Additional fields in REPORT frame

Proposal

Example of bandwidth allocation – Single queue report

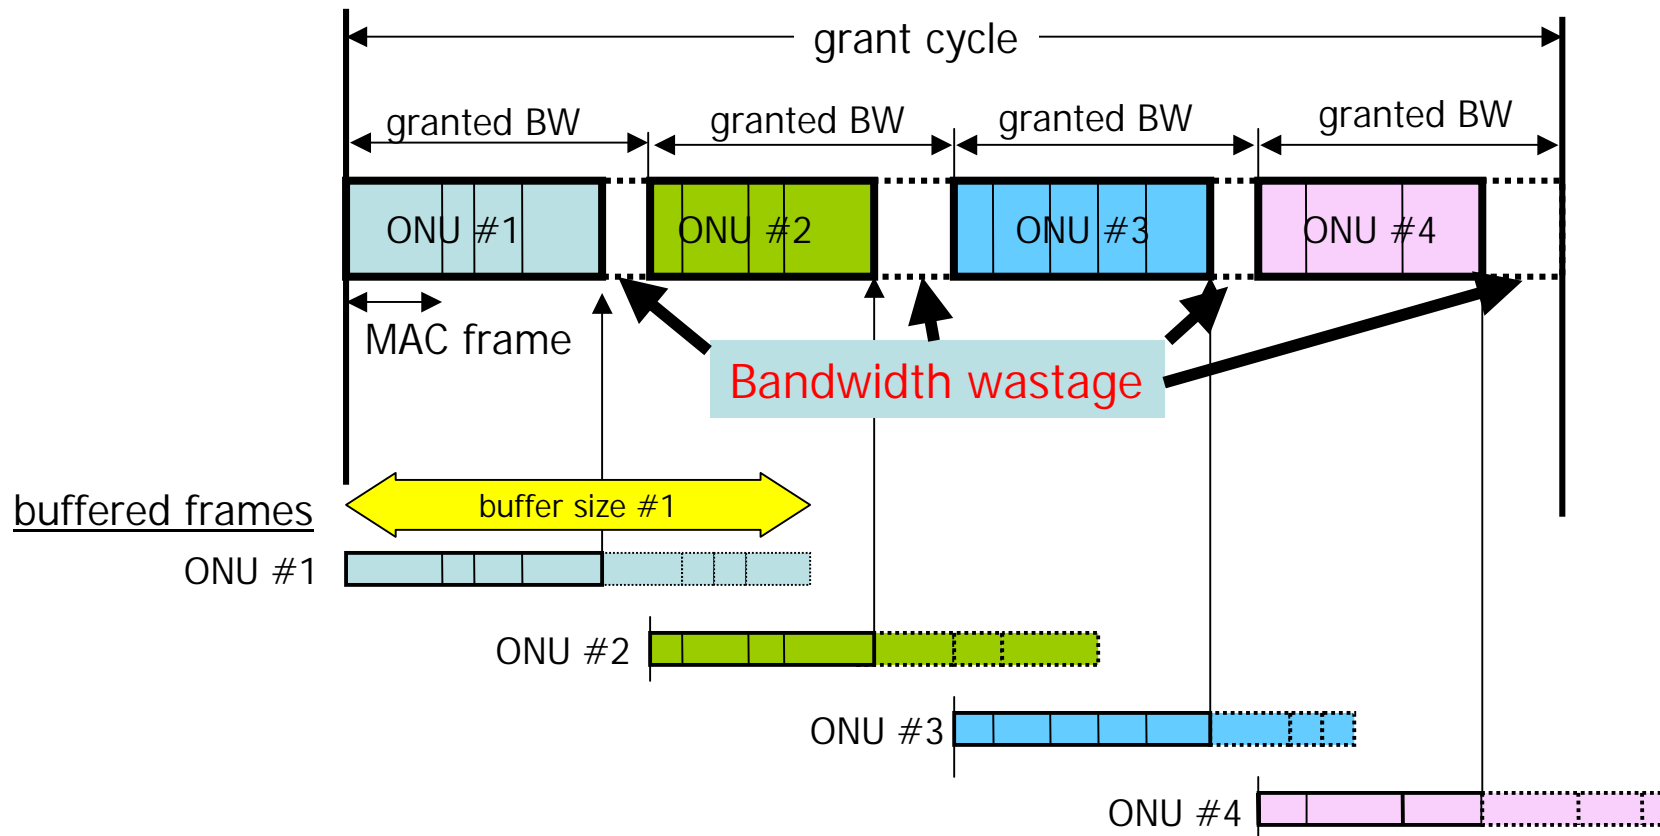
- When “Single queue report” is used, OLT doesn't know the size of frames that will be transmitted.
 - There are unused slots in the grant.

Example of bandwidth allocation – Multiple threshold reports

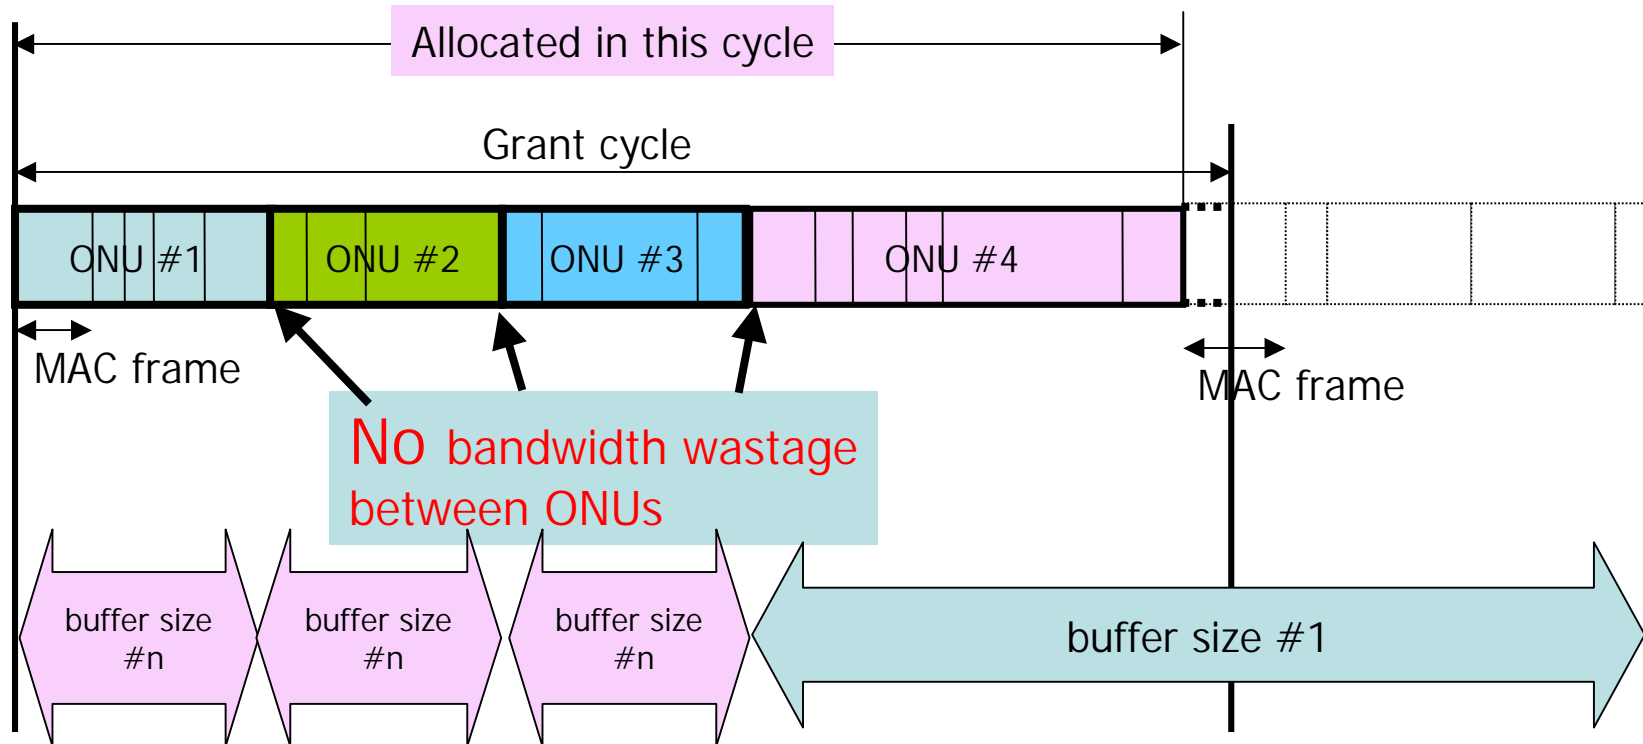
- OLT knows the size of frames that will be transmitted as “buffer size #n”.
 - ➔ No bandwidth wastage between ONUs.

Efficiency Comparison

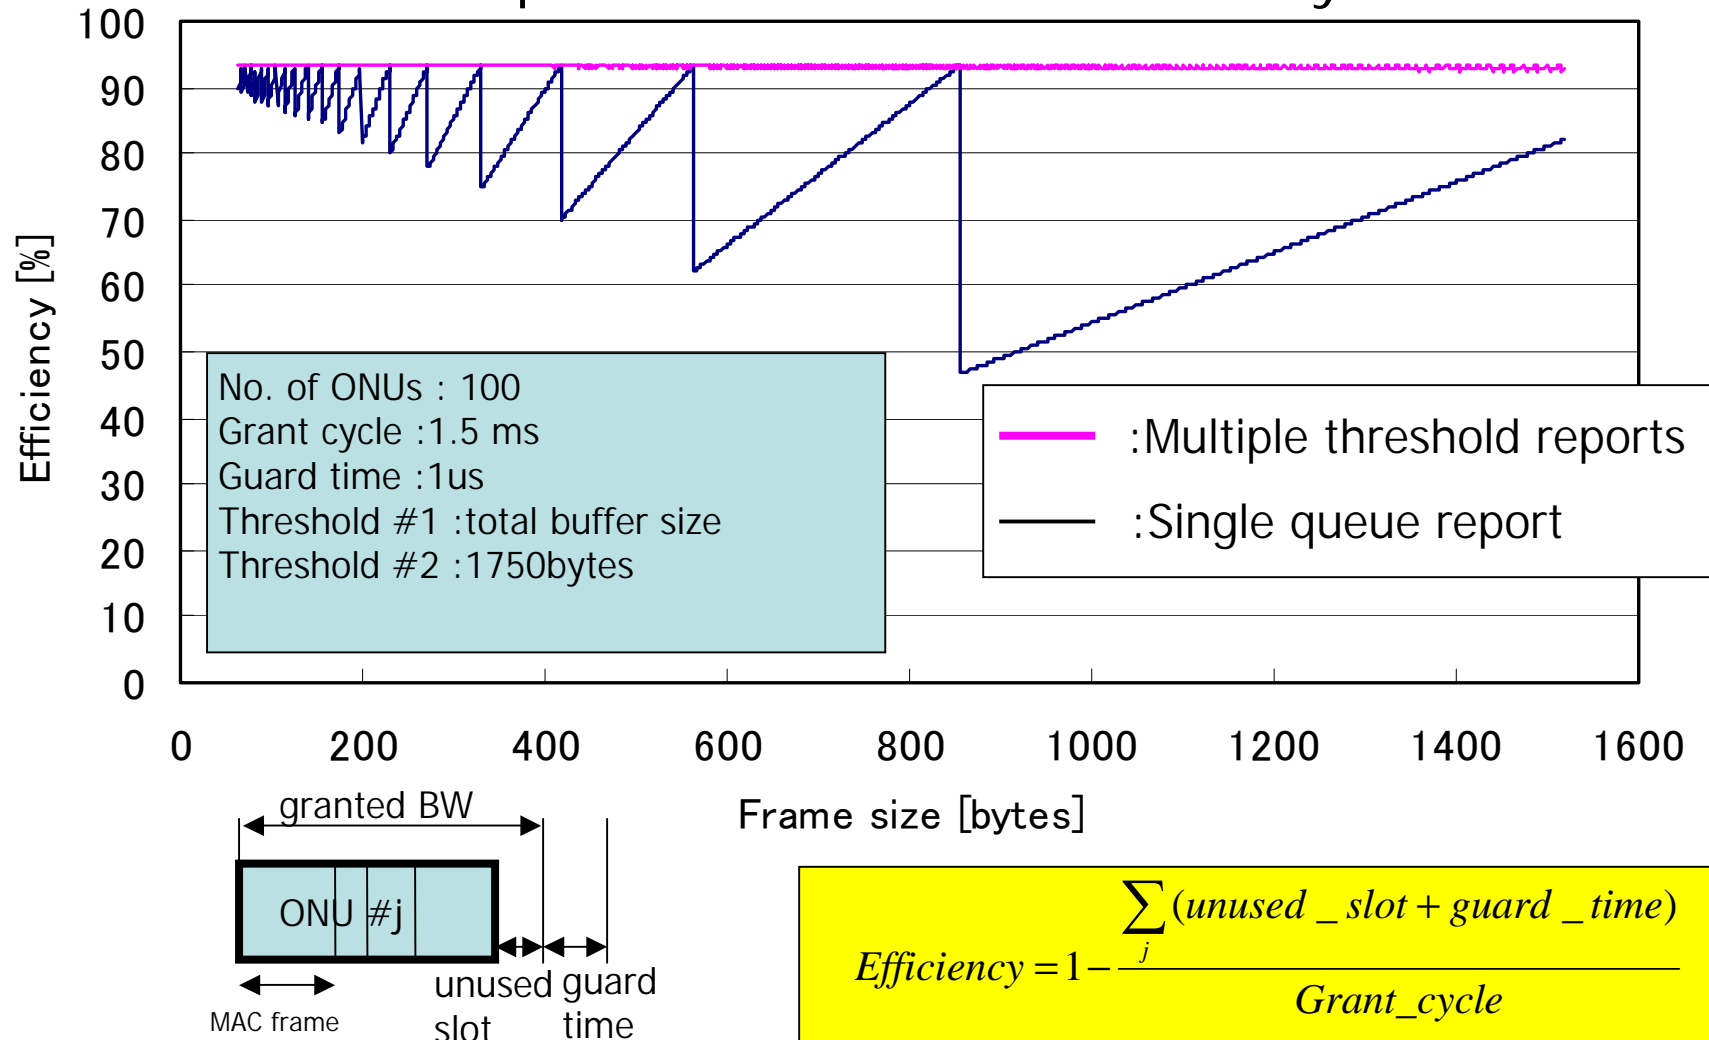
High efficiency can be achieved by “Multiple threshold reports”

Proposed REPORT message format

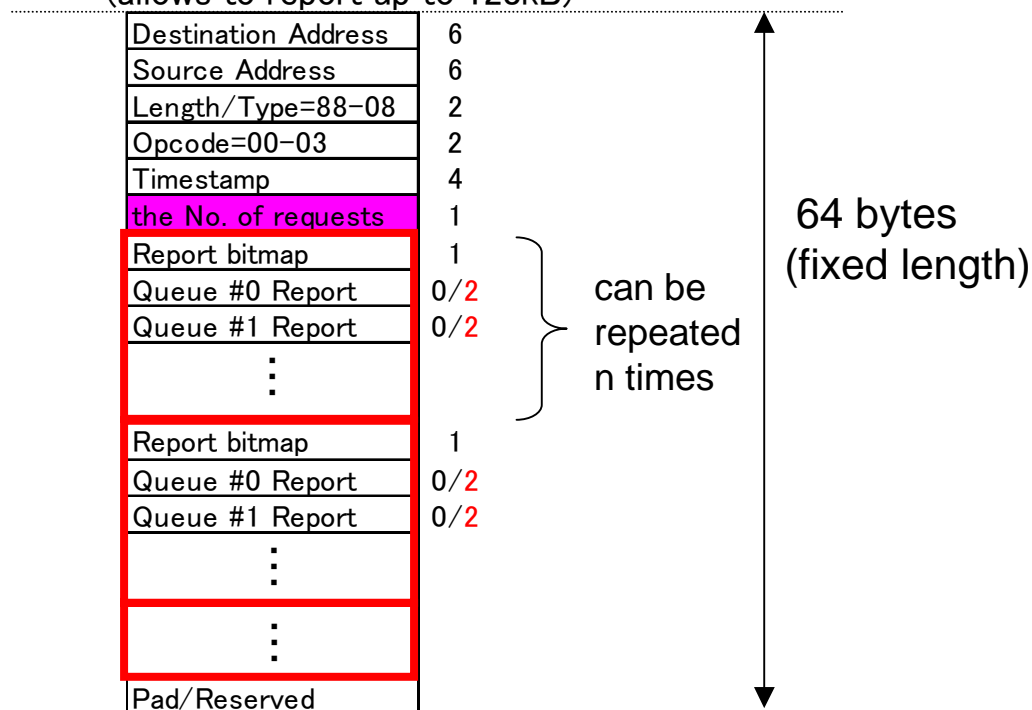
- A REPORT message **MAY** hold multiple sets of bitmaps and queue reports.
- The number of requests in a Report frame is decided by the ONU.
- OLT passes the requests according to “the number of requests” fields.
- Queue report field is an **16 bit field, 2 octets granularity** which is the same as the grant. (allows to report up to 128KB)

Queue report fields: **16bits**
2 octets granularity
 (allows to report up to 128kB)

- Add the following statement in Line 42, page122
 - (c) The granularity of Queue #n report is 2 octets.
 - (d) Add “the number of requests” field to specify the number of requests in the Report message.
 - (e) A Report frame may hold multiple sets of Report bitmap and Queue #n as specified in “the number of requests” field.
- Change the statement from “7 to 39” to “0 to 39” in Line 46, page122
- Change the Queue #n Report fields from 0/4 octets to 0/2 octets in Figure 56–20, page123
